# New Turbine “V” Series Service Filters

2020V/2040V fuel filter/water separator service filters for new Racor Turbine Series FV and VMA assemblies.

## Part Numbers

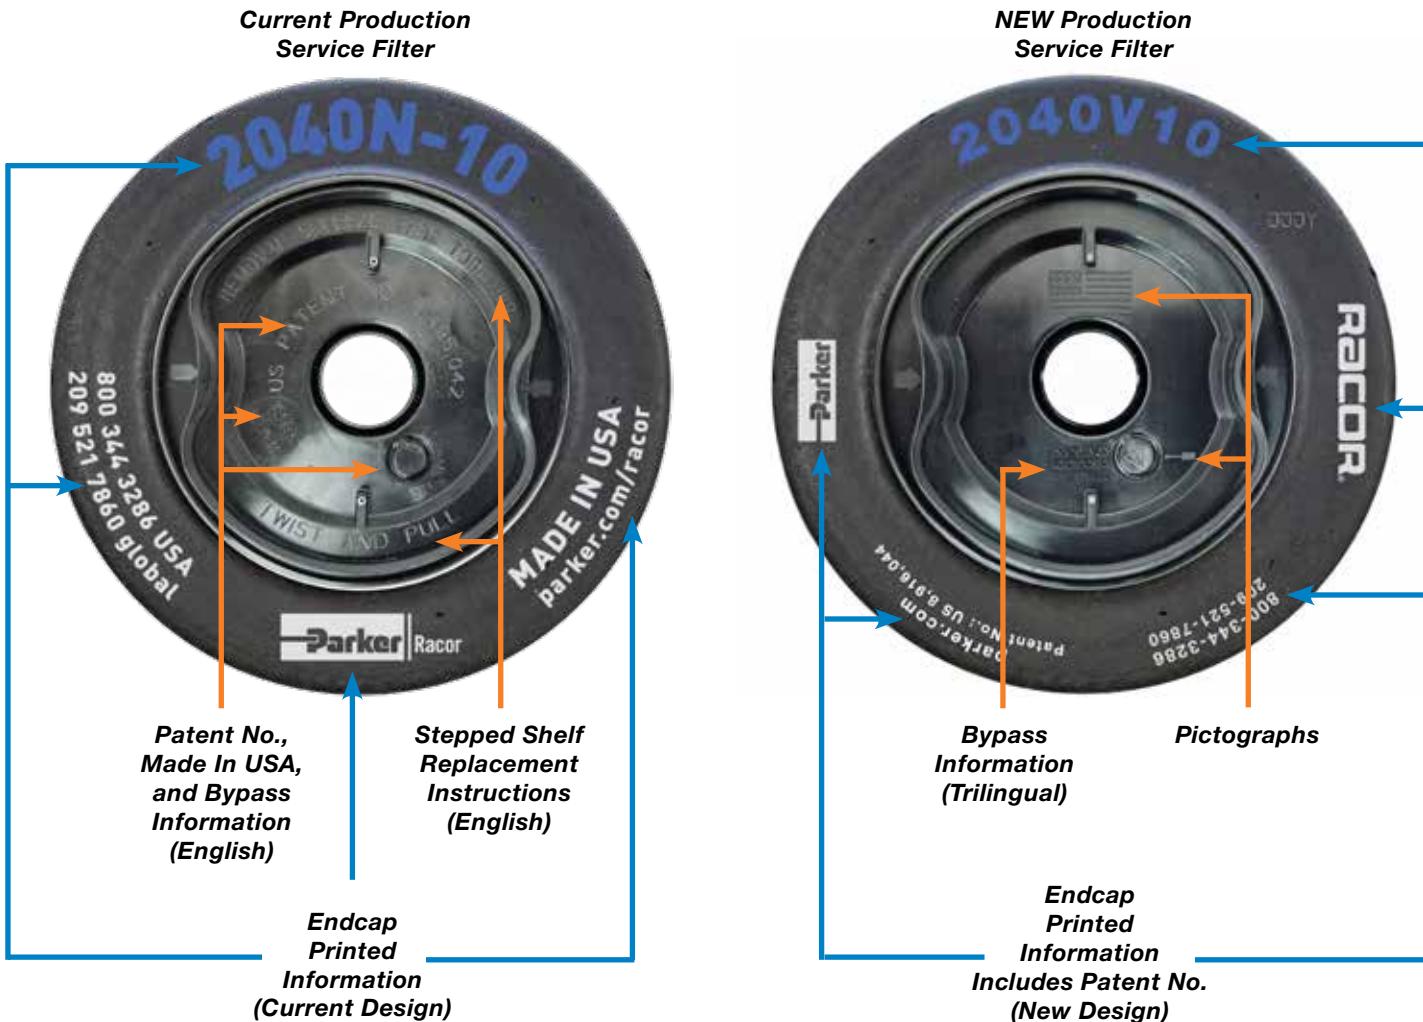
The Turbine service filters are designed for the new 900FV, 1000FV, 900VMA, and 1000VMA (marine application). The service filters are backward compatible with previous models. ***Note: Old and current service filter part numbers will not work in the new FV and VMA housings. New part numbers are backward compatible with previous models.***

Old Part #	Current Part #	New Part #	Release Date
2020SM-0R	2020N-02	2020V2	May 2021
2020TM-0R	2020N-10	2020V10	
2020PM-0R	2020N-30	2020V30	
2040SM-0R	2040N-02	2040V2	
2040TM-0R	2040N-10	2040V10	
2040PM-0R	2040N-30	2040V30

*This is a running change.*

The 2020N and 2040N filters will not work in the new FV or VMA model assemblies.

The 2020V and 2040V service filters are backward compatible for the following:

Assemblies	Models
900	FH, FG, FGM, FF, FE, MA and MAM
75900	FHX, FGX, FGM, MAX and MAXM
1000	FH, FG, FGM, FF, FE, MA and MAM
731000	FH, FG, FGM, MA and MAM
751000	FHX, FGX, FGM, MAX and MAXM
771000	FH, FG, FGM, MA and MAM
791000	FHV, FG, FGM, MAV and MAVM
